Bulker Q&As and CIs on the IACS CSR Knowledge Centre

COMMON STRUCTURAL RULES FOR
BULK CARRIERS

Chapter 8 - Fatigue check of structural details

Figure 3: Relative displacement between the transverse bulkhead and the transverse web or floor

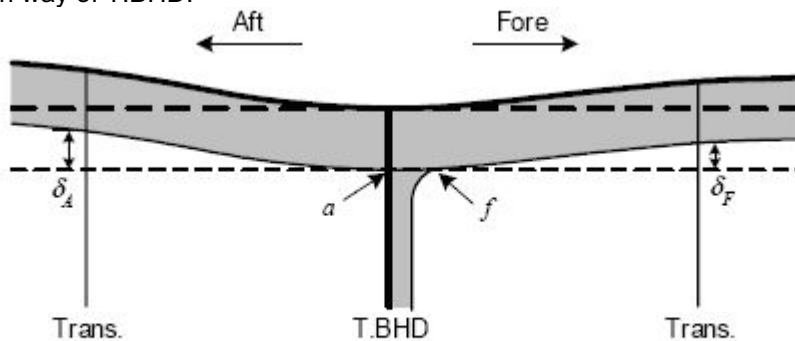
1. Could you forward our question below to IACS PT with respect to JBP Ch 8 Sec 4 2.3.6 for fatigue analysis of longitudinals in way of T.BHD.

342 attc	8/4.2.3.6	Question	Transverse BHD	2007/5/22	Relative displacement of transverse BHD. See the attached question.	The relative deflection for double bottom is defined as follows. (1) On the bottom The base line is defined as the line between connecting points of the floors to bottom in way of fore and aft of lower stools. The relative deflection is defined as the deflection of the connecting points of the adjacent floors to bottom measured from the base line. (2) On side shell The case 2 as shown in your attached document is correct.	Y
355	8/5.2.1.1	Question	Parameter correction	2007/3/20	In Chapter 8 Section 5,[2.1.1], the following parameters needs to be more specific: 1) "AQ" is the shear area of the cross deck: does it includes the shear area of all plates and of all ordinary stiffener, as shown on Figure 2 ? 2) "bS" is the breadth of the remaining deck strip beside the hatch opening: is it the total breadth on both sides or is it only on one side? If it is the latest case, it should be identical to "b" defined in [3.1.1]. 3) "LC" is the length of the cargo area, it should be noted LC, with "C" as and index.	1) The shear area "AQ" is the effective shear area of the whole section shown in figure 2 with respect to the ship's longitudinal direction. For the determination of the effective shear area the consideration of only the plate elements is sufficient, and the stiffeners can be neglected. 2) "bs" is only the remaining deck strip on one side, so it is identical to "b" in [3.1.1] 3) This is an editorial typo: "C" should be as an index in "LC". Also Included in Corrigenda 5

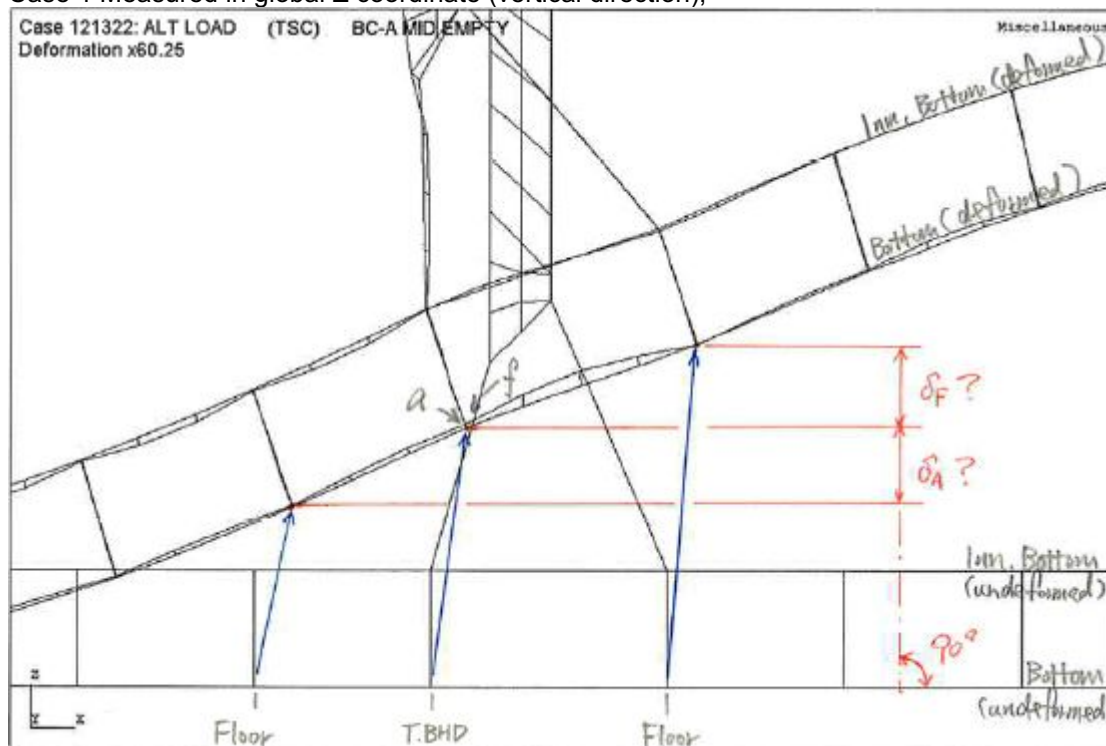
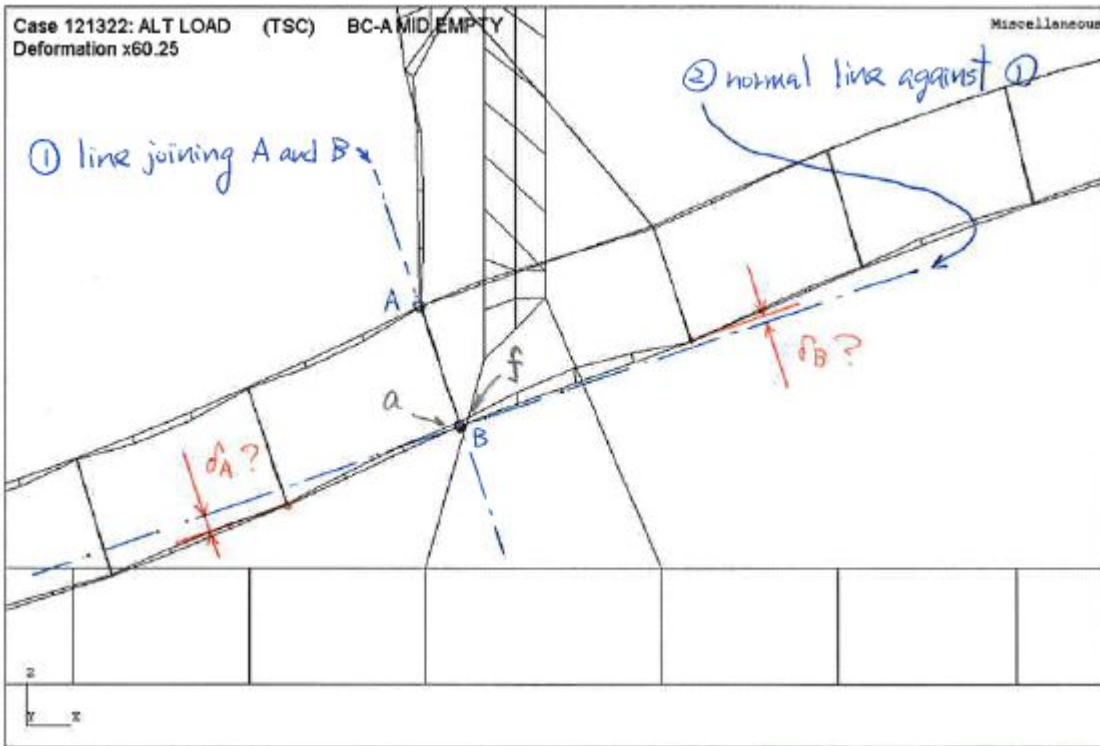
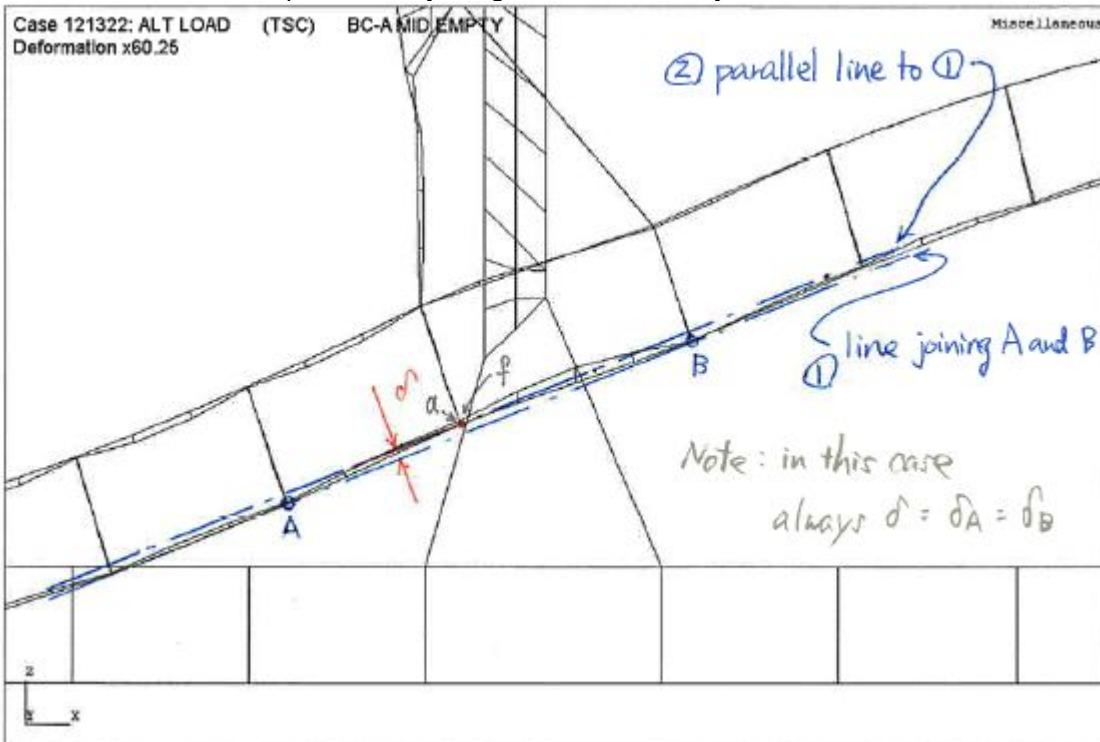
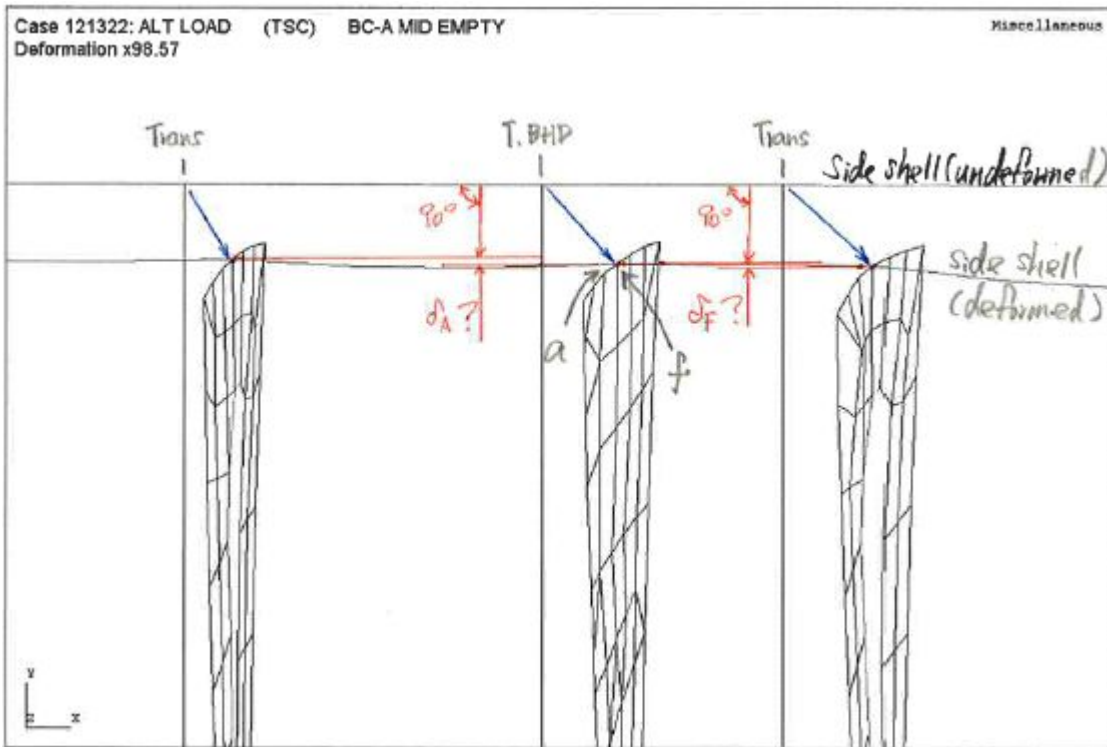
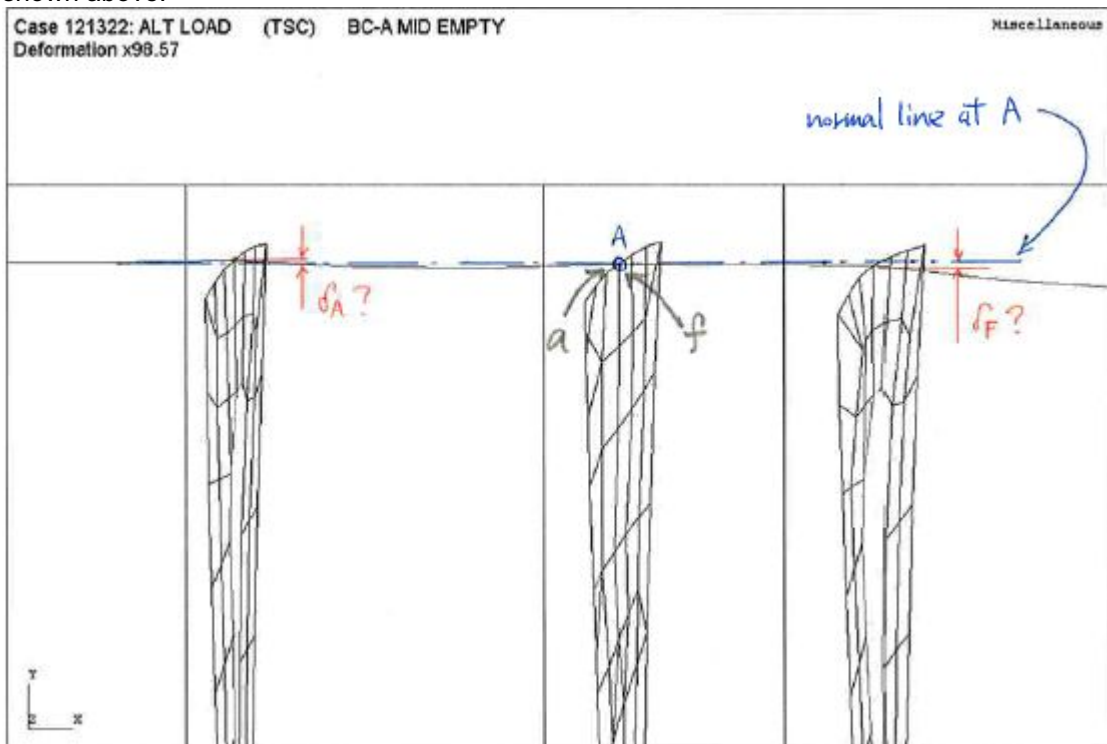
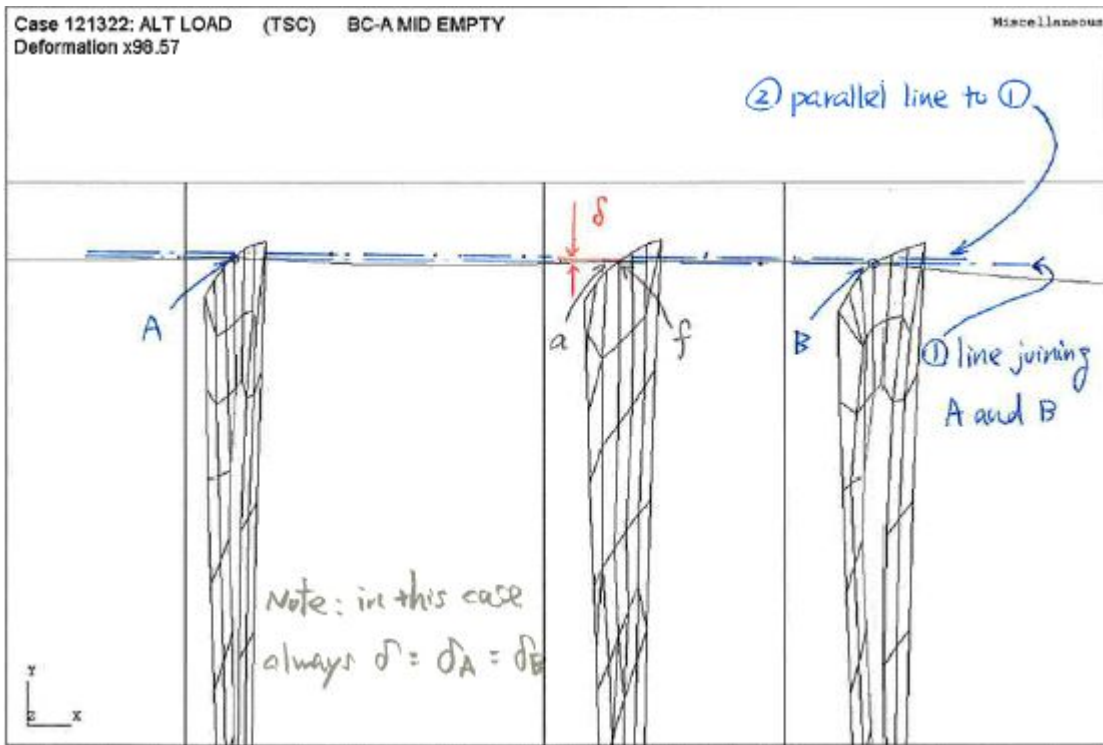
2. Relative displacement δ_A , δ_F ;

Example displacement in alternate condition is shown below with undeformed shape. We have considered how to treat this relative displacement and some ideas are illustrated. Could you confirm which interpretation (Case 1 ~ 3) is correct?

2.1. On bottom shell;

Case 1 Measured in global Z coordinate (vertical direction);

Case 2; Measured from parallel line at the location considered;

Case 3; Measured from parallel line joining intersection of adjacent floors;

2.2. On side shell;

Case 1 Measured in global Y coordinate (transverse direction);

Case 2 Measured from normal line at the location considered;
However, it seems difficult to make the normal line as there are no connecting point such as inner bottom as shown above.

Case 3 Measured from parallel line joining intersection of adjacent transverse webs;

1. For bottom structure:

- The relative displacement is defined as the distance measured from the intersection of adjacent floor to bottom / inner bottom to the base line;
- The base line is defined as the line between intersection points of the floors to bottom / inner bottom in way of fore and aft of lower stools; (blue lines in Fig. 1)
- The displacement with a direction from the flange of considered stiffener to the attached plate is defined as positive.

2. For side shell structure:

- The relative displacement is defined as the distance measured from the intersection of adjacent ring to attached plate to the base line;
- The base line is defined as the line perpendicular to the transverse bulkhead; (blue lines in Fig. 2)
- The displacement with a direction from the flange of considered stiffener to the attached plate is defined as positive.

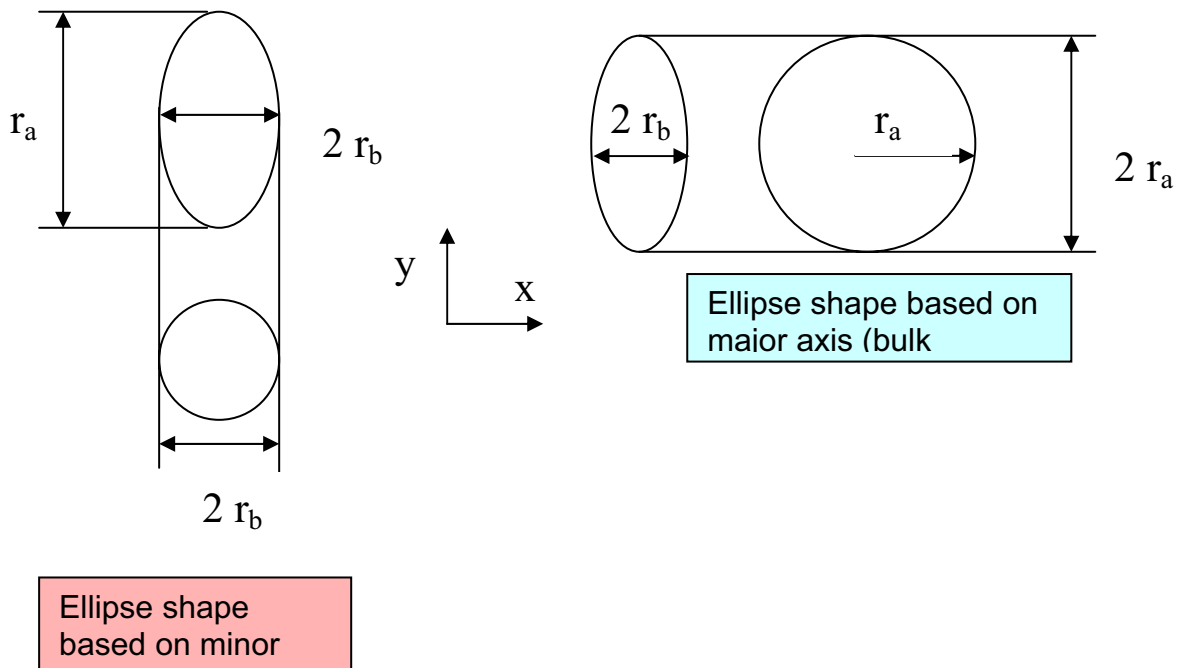
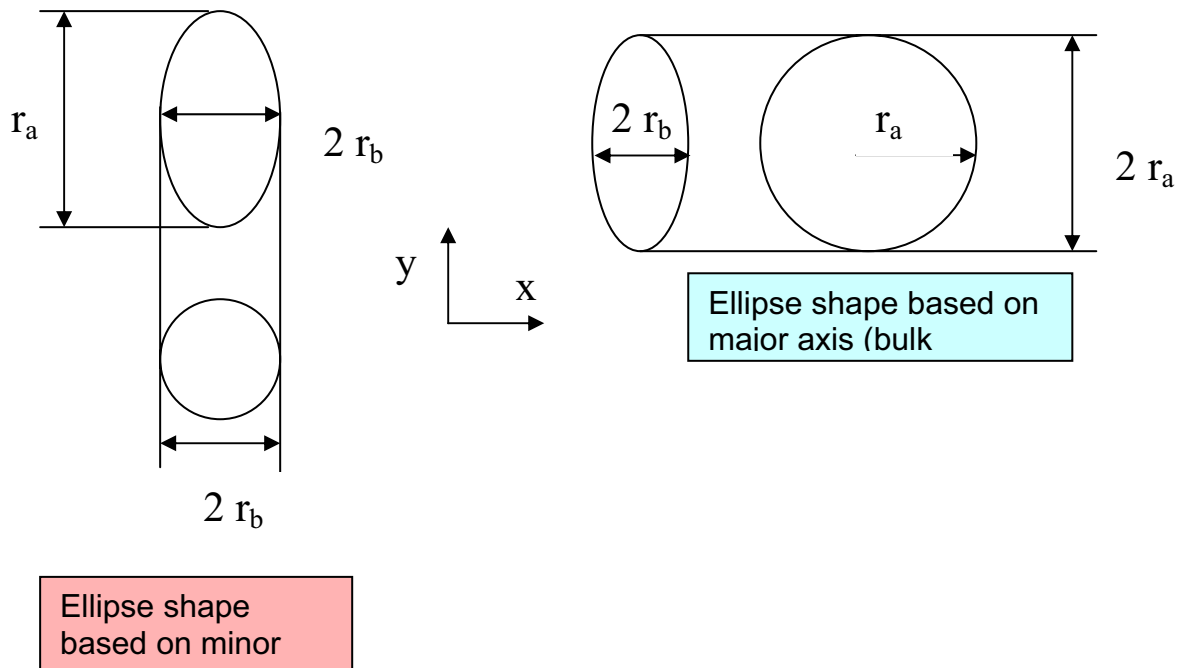
Ellipse shapes 4, 5 and 6 are other kind of ellipse shape that those used for bulk formula. The reference axis is the minor one.

We can see that r_b radius is a more conservative basis than r_a to evaluate the influence of an elliptic shape. The error is a bit less than for r_a and the K_t obtained is over evaluated (r_b basis) instead of being under evaluated (r_a).

385 attc	8/5/3.1.1	Question	Elliptic Corners	2007/3/9	<p>We have some doubts on the correction factor for elliptic corners which appears in the formula of the stress concentration factor in Ch 8, Sec 5, [3.1.1]. We see on the knowledge centre under the answer to question 223 that "The requirement on hatch corner fatigue check will be revised as soon as possible, including a technical background". However, to help for this revision, we would like to ask you to consider the attached document. It shows that some misunderstanding has occurred between "ra" and "rb". Please consider this proposal?</p>	<p>Having considered your attached document, it seems effectively that "ra" and "rb" are not defined correctly. We will consider it at the time of revision of this requirement.</p>	Y
